## DECISION OF THE PLANNING ADMINISTRATOR

**CLASS 3 SITE PLAN REVIEW / CLASS 2 ADJUSTMENT / TREE REGULATION  
VARIANCE CASE NO.: SPR-ADJ-TRV22-36**

**SUMMARY:** Proposed development of a Vietnam War Memorial.

Submitted: Site Plan Review  
Sheet Title: Tree Protection Plan

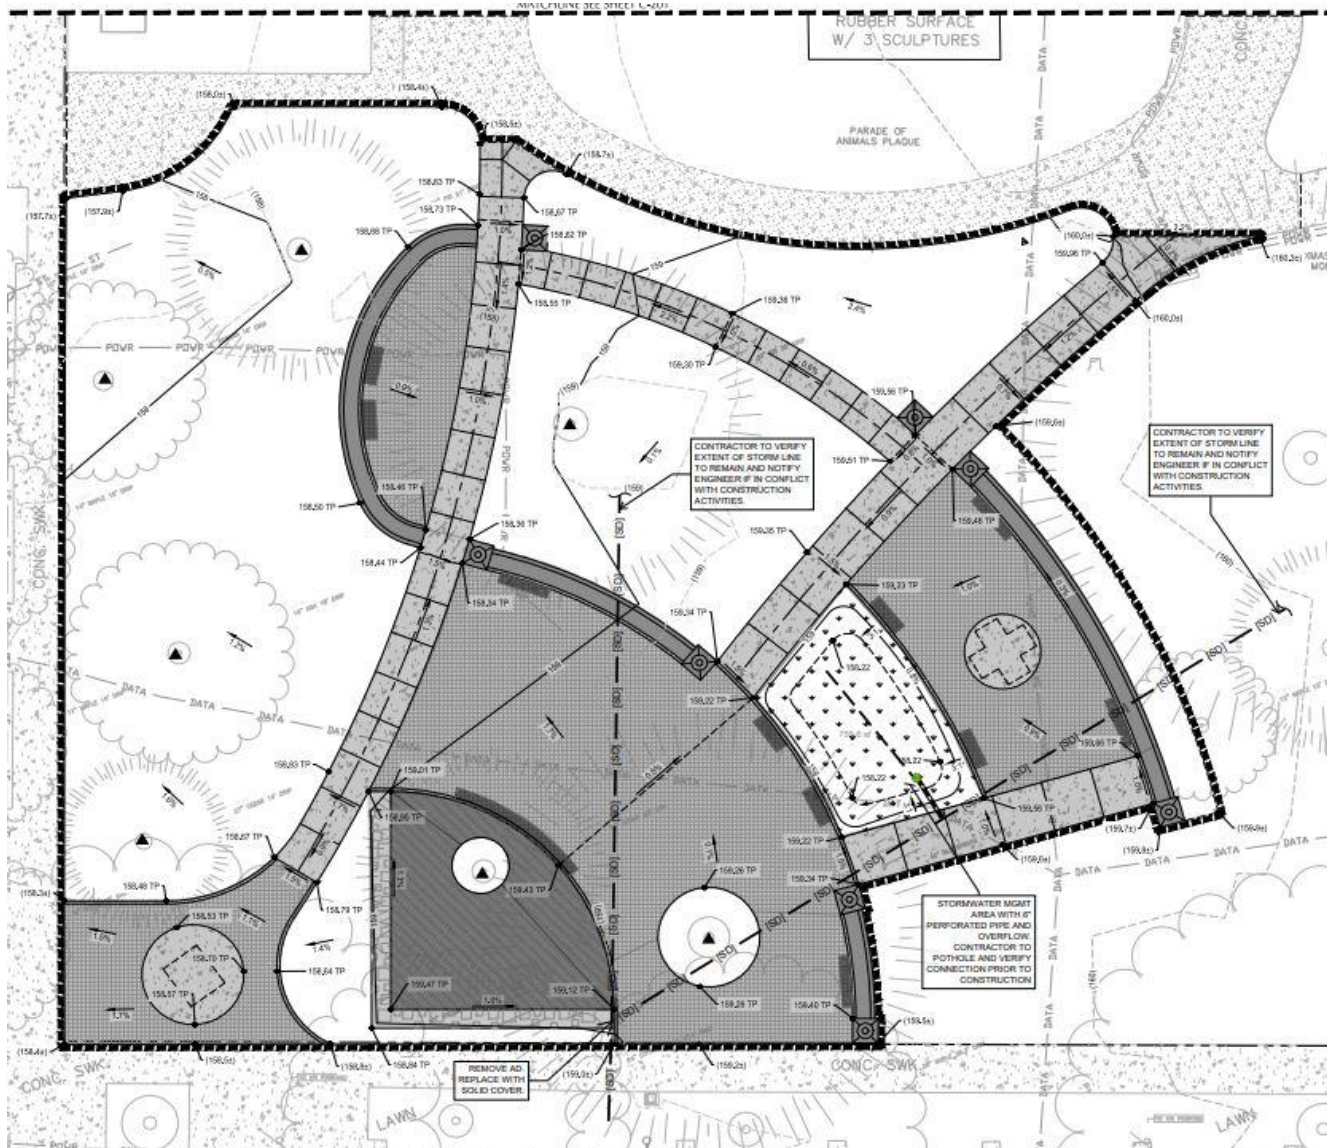
Tree #1109 (40" Douglas Fir): This tree is primarily surrounded by softscape with some pathways in the outer half of the root zone. The pathways will be elevated above the roots with drain rock between the roots and pavement to allow good air and moisture exchange. Prescriptive measures for working around the significant roots shall be included on the final Permit Drawing.

Tree # 10642 (45" Blue Atlas Cedar): Per the arborist's recommendations, the design shall incorporate permeable pavers at an elevation above the roots in order to provide drain rock between the roots and base rock of the permeable pavers. This system will allow good air and moisture exchange. Prescriptive measures for working around the significant roots shall be included on the final Permit Drawing.
